PLANNING AND ZONING CASE CHECKLIST

Project Number: SP2019-001
Project Name: T3 Chiropractic
Project Type: SITE PLAN
Applicant Name: TRISTON GENERAL CONTRACTOR
Owner Name: FALLS, DAVID C & TERRI L
Project Description:

Project Number SP2019-001	Owner FALLS, DAVID C & TERRI L	Applied 1/17/2019	LM
Project Name T3 Chiropractic	Applicant TRISTON GENERAL CONTRACTOR	Approved	
Type SITE PLAN		Closed	
Subtype		Expired	
Status Staff Review		Status	
 Site Address 903 N GOLIAD ST		City, State Zip ROCKWALL, TX 75087	
		Zoning	
Subdivision GARNER	Tract NULL	Block ALL 26	Lot No NULL
		Parcel No 3730-0026-0ALL-00-OR	General Plan

Type of Review / Notes	Contact	Sent	Due	Received	Elapsed Status	Remarks
SP2019-001 Site Plan for T3 Chiropractic Office: Please address the following comments (M= Mandatory Comments; I = Informational Comments)						
?						This is a request by Reese Baez of Triton General Contractors on behalf of Kevin Lefere for the approval of a site plan for a medical office building on a 0.26-acre portion of a larger one (1) acre tract of land identified as Block 26 of the Garner Addition, City of Rockwall, Rockwall County, Texas, zoned Planned Development District 50 (PD-50) for Re

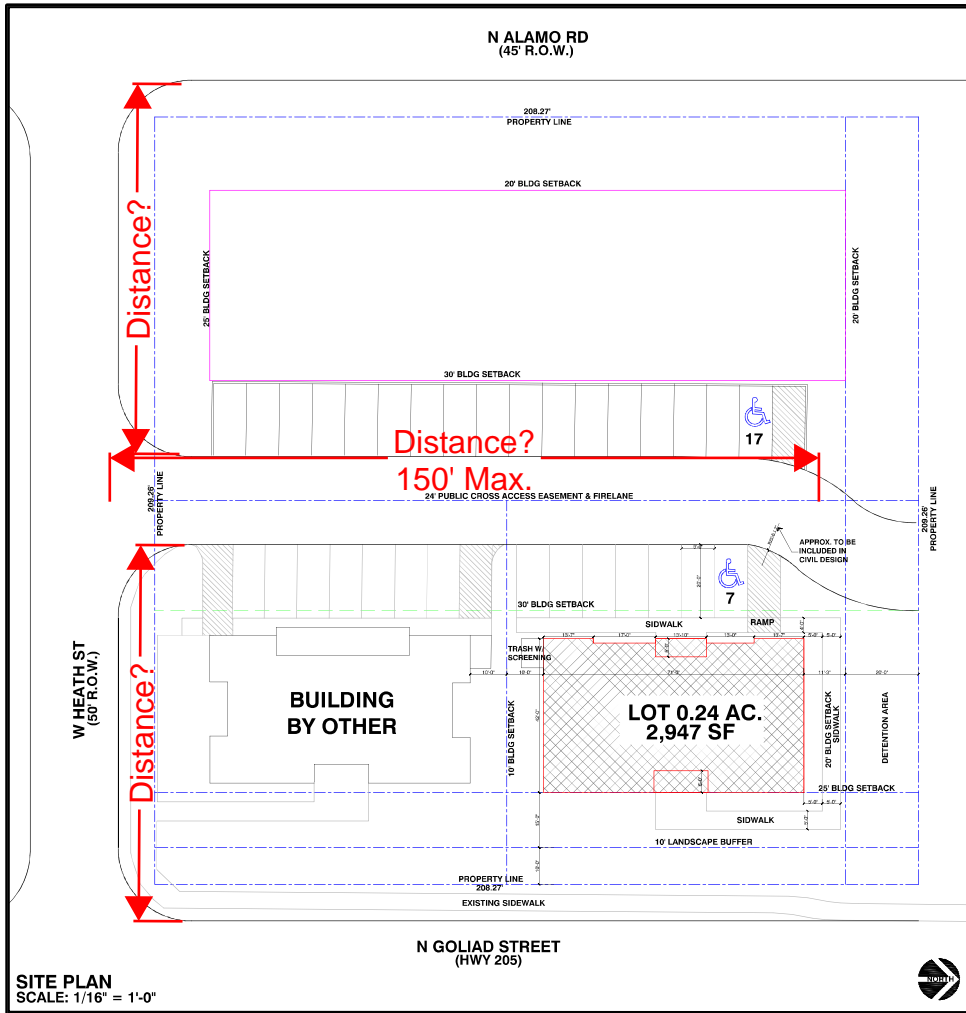
- 4% Engineering Inspection Fees
- Impact fees.
- Min 20' utility easements.
- No structures in easements.
- Fire lane easement to be on plat.
- Fire lane to be 24' wide with 20' radii.
- Parking to be 20'x9'
- No dead-end parking.
- Driveway spacing must be labeled on Site Plan.
- Must have detention. Manning's "c-value" is per zoning for the entire property. 4:1 max slope. No vertical walls allowed in detention easement
- No trees within 5' of public utilities.
- Retaining walls 3' and over must be designed by a licensed engineer. All walls to be rock or stone. No smooth concrete walls.
- Must meet all City Engineering Standards.

LANDSCAPE PLAN
SCALE: 1/8" = 1' - 0"

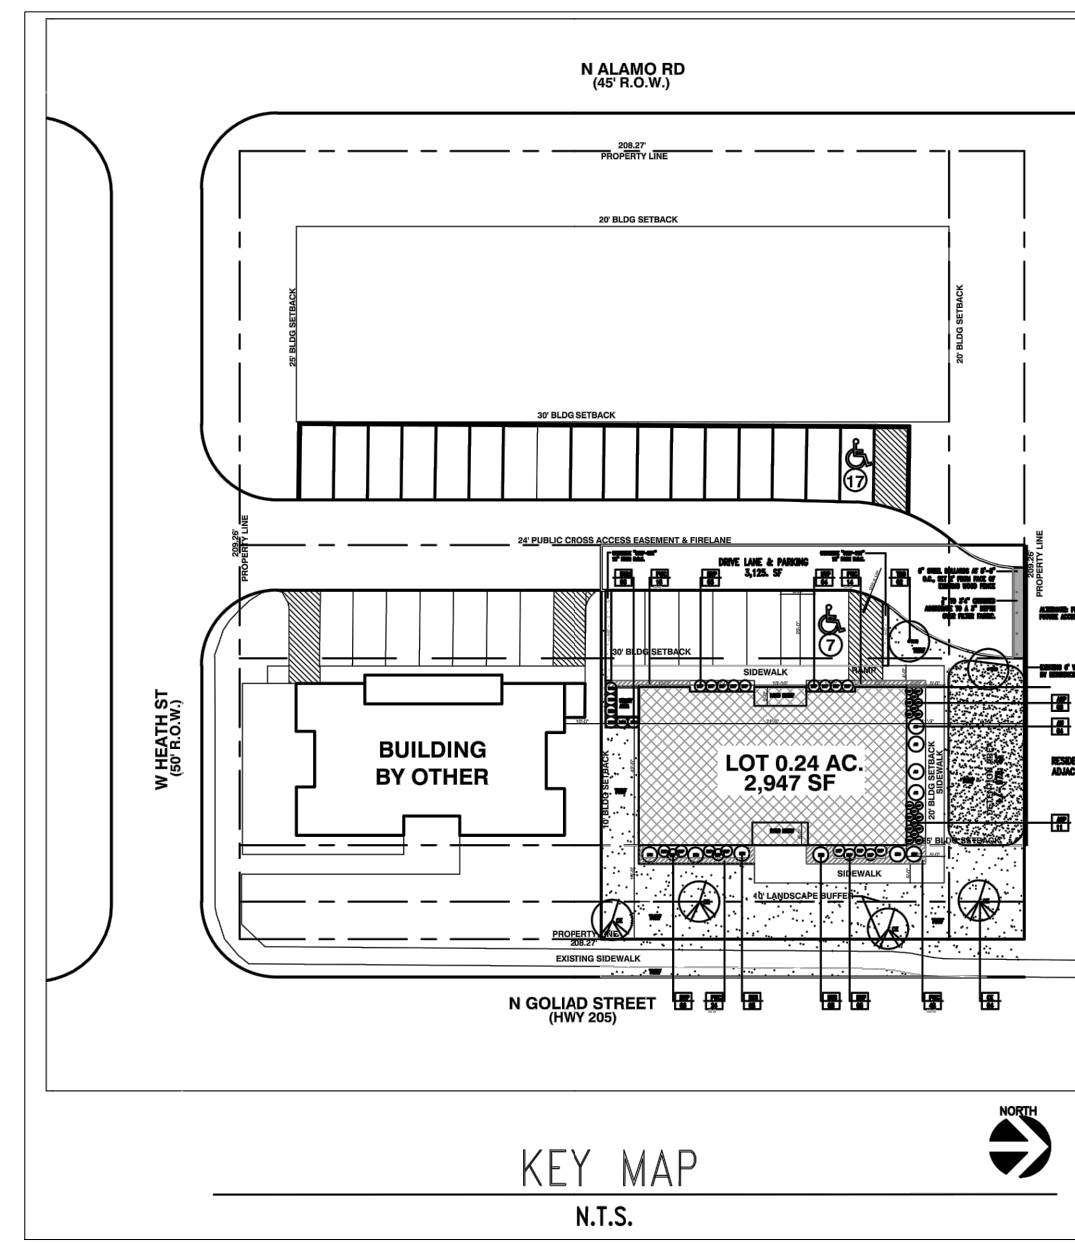
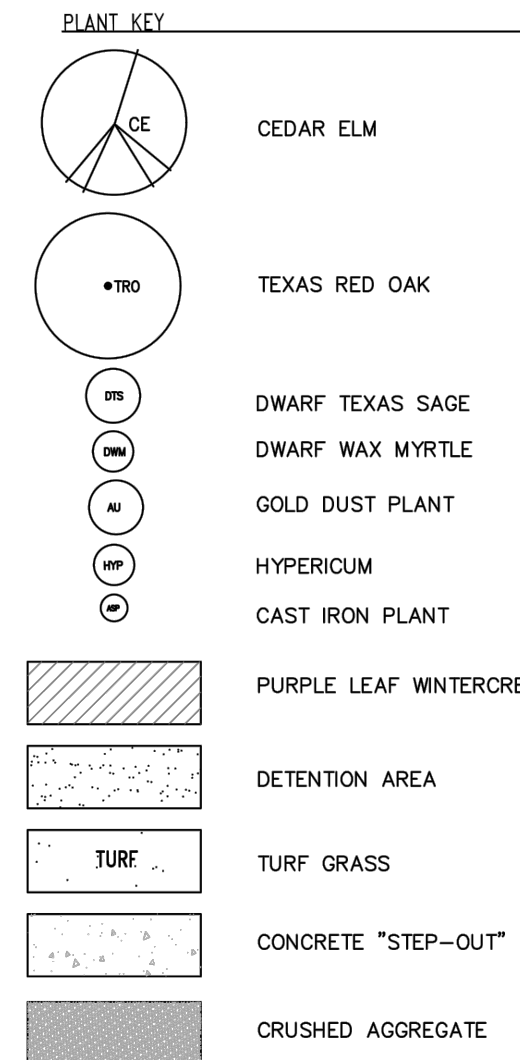
Show Existing and Proposed Utilities.
Add note, " No trees within 5' of utilities."

TYPICAL PARKING ISLAND-PLAN

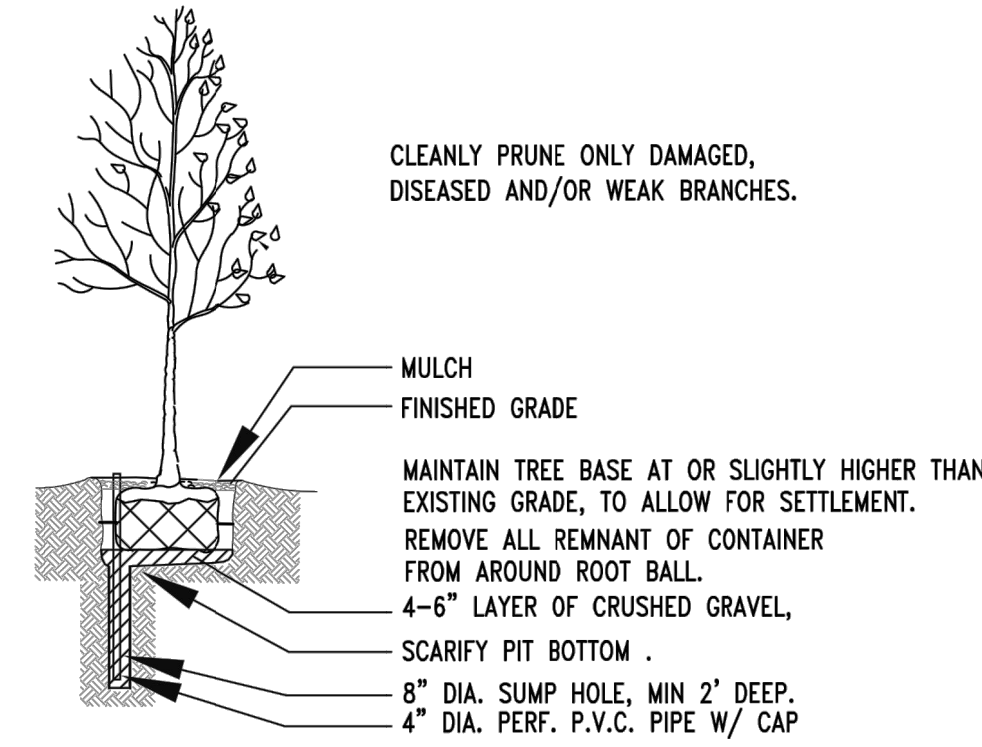
MUST INSTALL SUMP
